SIB 27 01 20

RECALL 20V-185: REPLACING THE FLEX DISC AND INSPECTING THE TRANSFER CASE

This Service Information Bulletin (Revision 65) replaces SI B27 01 20 **dated September 2020**.

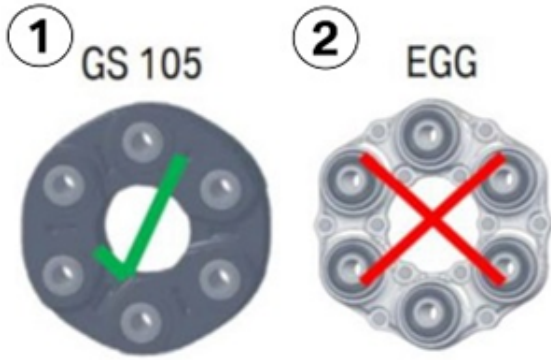
No further action is required if a black, corded rubber style (GS105) flex disc is installed (1).

If an aluminum style **"EGG"** (2) is installed, it **must** be replaced with a **"GS 105"** (1).

The transfer box output flange must then also be inspected for friction rust.

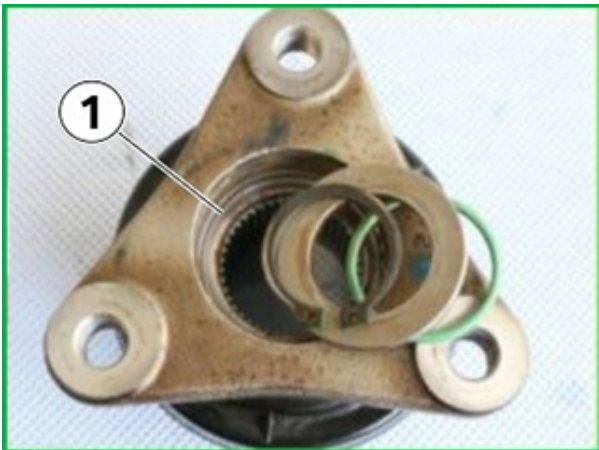
Typical output flanges without friction rust build up (1).

No further repair is necessary if there is no friction rust around the splines of the output flange.

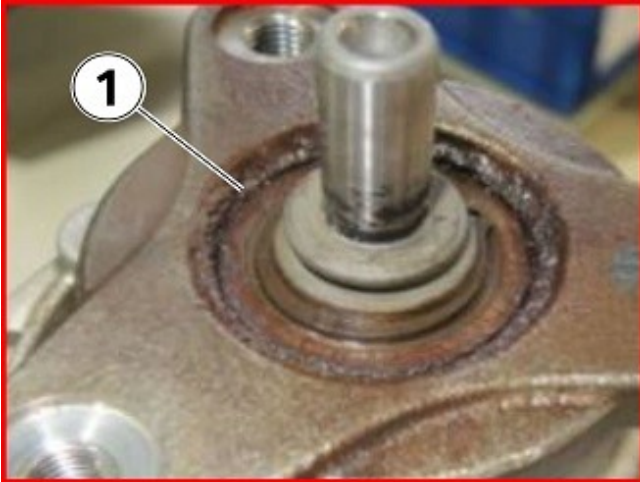
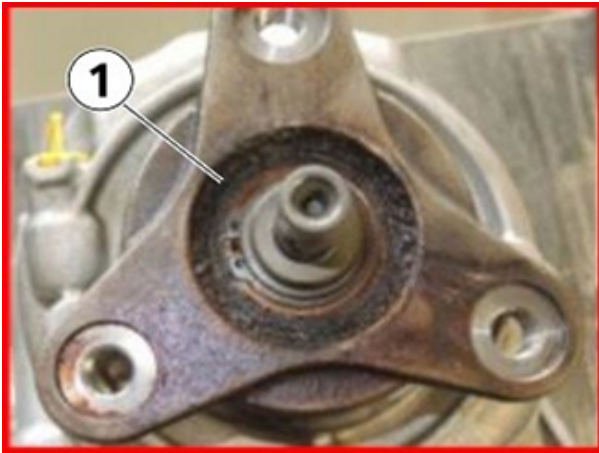
Output flanges with friction rust (1). Flanges with excessive friction rust will require transfer case replacement.

If rust build up cannot be determined by visual inspection, the flange will need to be removed for further diagnosis.

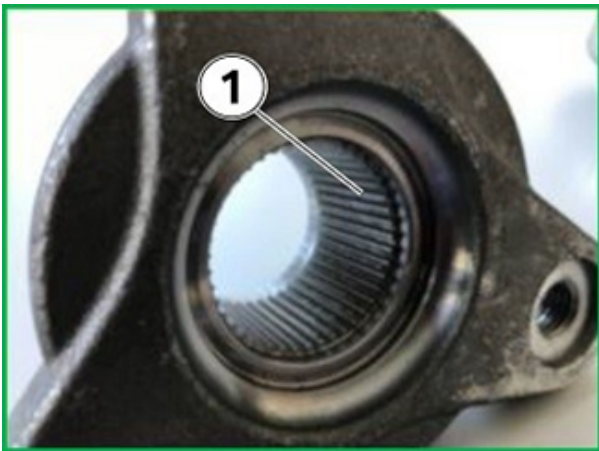
Typical flange and output shaft **without** any friction rust damage (1). Reinstall the flange (with new radial oil seal, O-ring and retaining ring) and reassemble the vehicle with new flex disc.

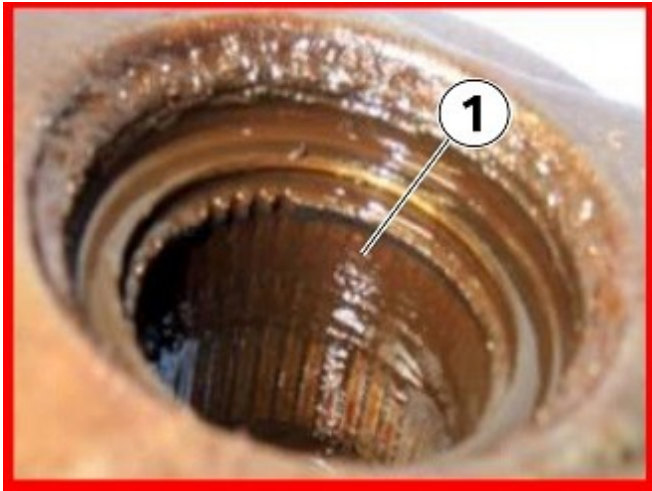
Flange and output shaft **with** friction rust damage (1). The transfer case will need to be replaced (with new flex disc).

NOTE: The transfer case needs to be replaced if either the flange or the output shaft are worn.

Follow Repair Instruction **27 10 020 Installing exchange transfer box (ATC 35L)**.
